Northfleet Central 1 Limited

Northfleet Harbourside, Gravesham

August 2023

Transport Assessment Addendum

Figure 2.1: Walking Routes and 800m Isochrones

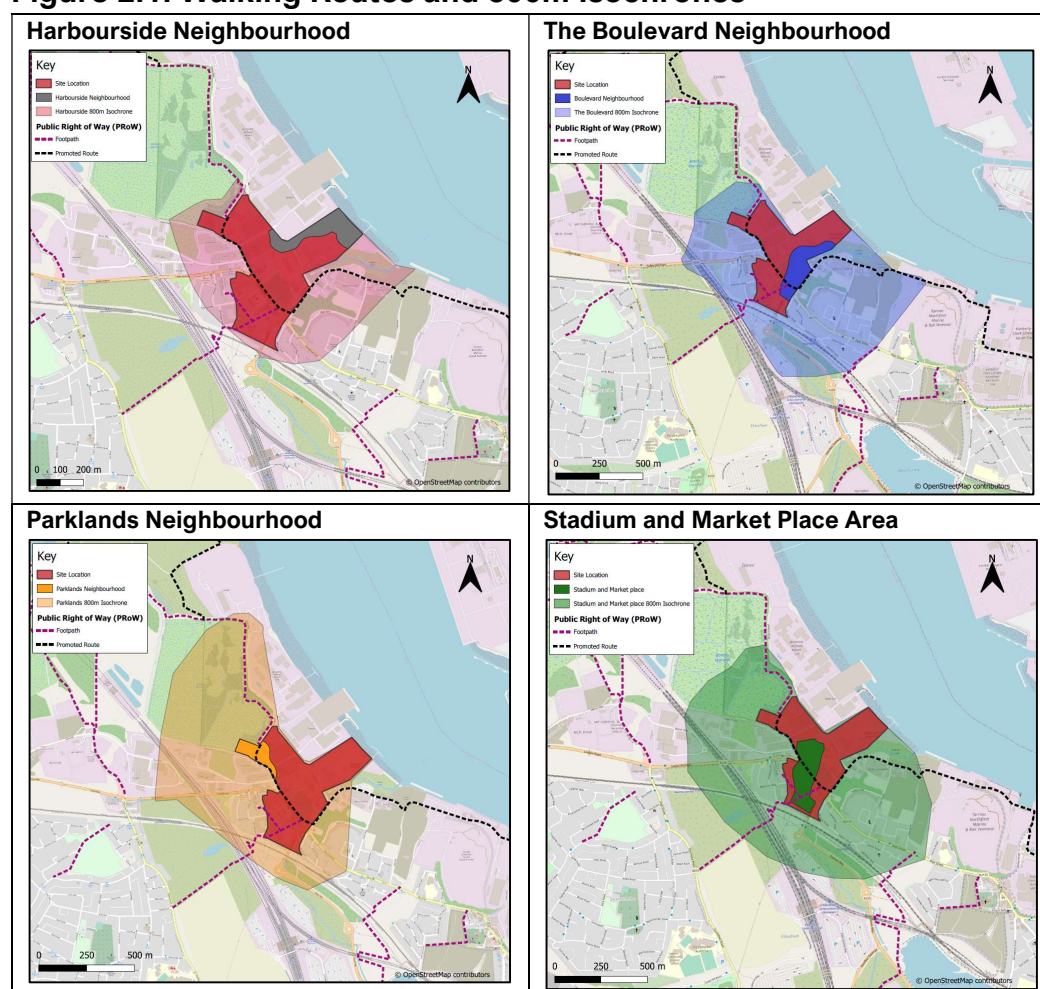
Figure 2.2 only shows the 2 kilometre walk isochrones and not the 800 metre isochrones as well, which are helpful in illustrating what is accessible within a 10 minute walk. The 800 metre isochrones should also be provided.

Topic	Response
Transport Assessment	
In paragraph 1.2 it should be noted that the site is nearer to Gravesend than Dartford, with it being four kilometres from Gravesend town centre.	This update is provided at Paragraph 1.5
Figure 2.2 only shows the 2-kilometre walk isochrones and not the 800 metre isochrones as well, which are helpful in illustrating what is accessible within a 10 minute walk. The 800 metre isochrones should also be provided.	Figure 2.1 and Appendix C present these isochrones
Paragraph 2.13 refers to bus stops on Taunton Road. A description of the walking route between the site and the bus stops should be provided, include the crossing opportunities.	A description of this walking route is provided at Paragraphs 2.5-2.9.
Paragraph 2.29 notes that accident data from Crashmap has been analysed and not data from Kent County Council (KCC). An analysis of the KCC data should be provided as part of a supplementary Transport Assessment.	A full accident review using KCC accident data is presented at Paragraphs 2.11 to 2.19

Figure 4.1: Road Hierarchy Plan

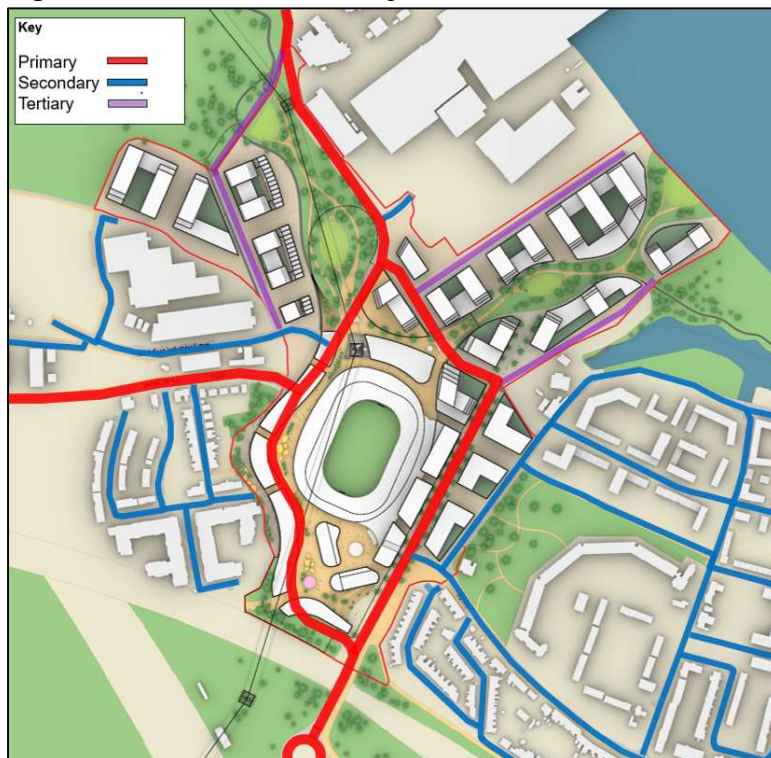
The proposed HGV routes shown on Figure 4.1 are supported. HGV's associated with construction should be restricted to the identified routes.

Figure 4.3: Proposed Bus Routes

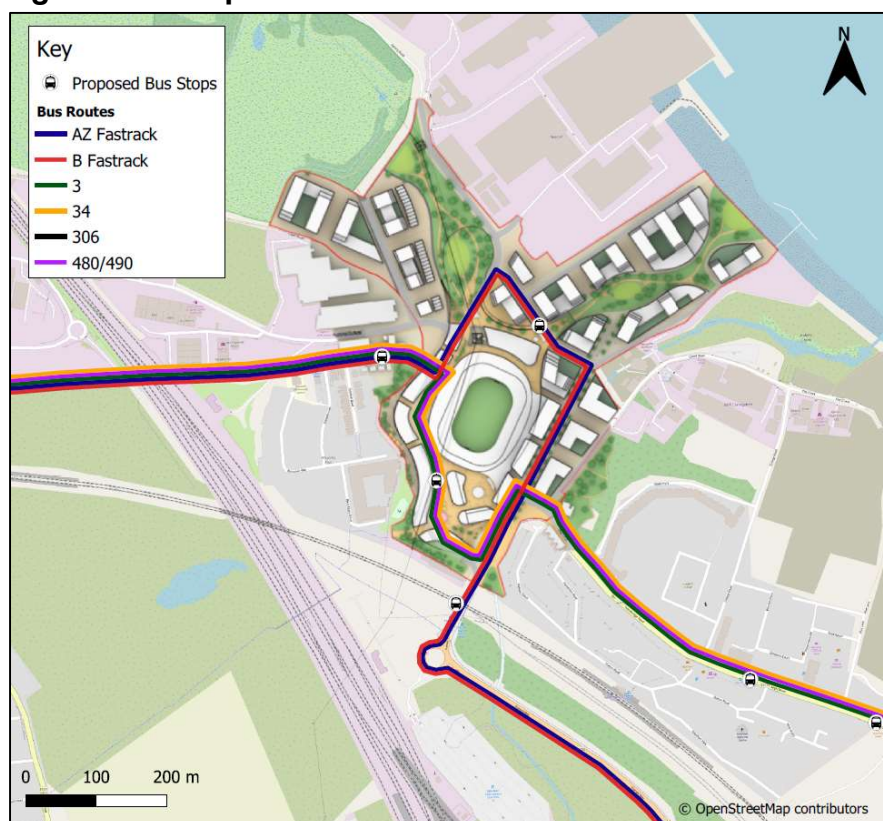
Where would the bus stops within the site be located (this should be shown on a plan) and what facilities would be provided at these bus stops? and	See Figure 4.3 and Paragraph 4.23
How would the proposed segregated Fastrack route affect existing Fastrack journey times?	This calculation is presented at Paragraph 4.24
What are the proposals for commercial bus services? In addition to Fastrack, routes 3, 34, 306, 480 Sapphire, 490 Sapphire and X55 currently serve stops within the site. How are the bus stops known as	A section on the commercial bus services is provided

- 4.22 The Fastrack bus service would stop within the site at the Mobility Hub located at the centre of the site. This bus stop would benefit from a bus shelter, bench, timetables and raised kerbs to ensure access to the buses by those with mobility impairments can be achieved. The proposed Fastrack bus route is shown within **Figure 4.3** overleaf.
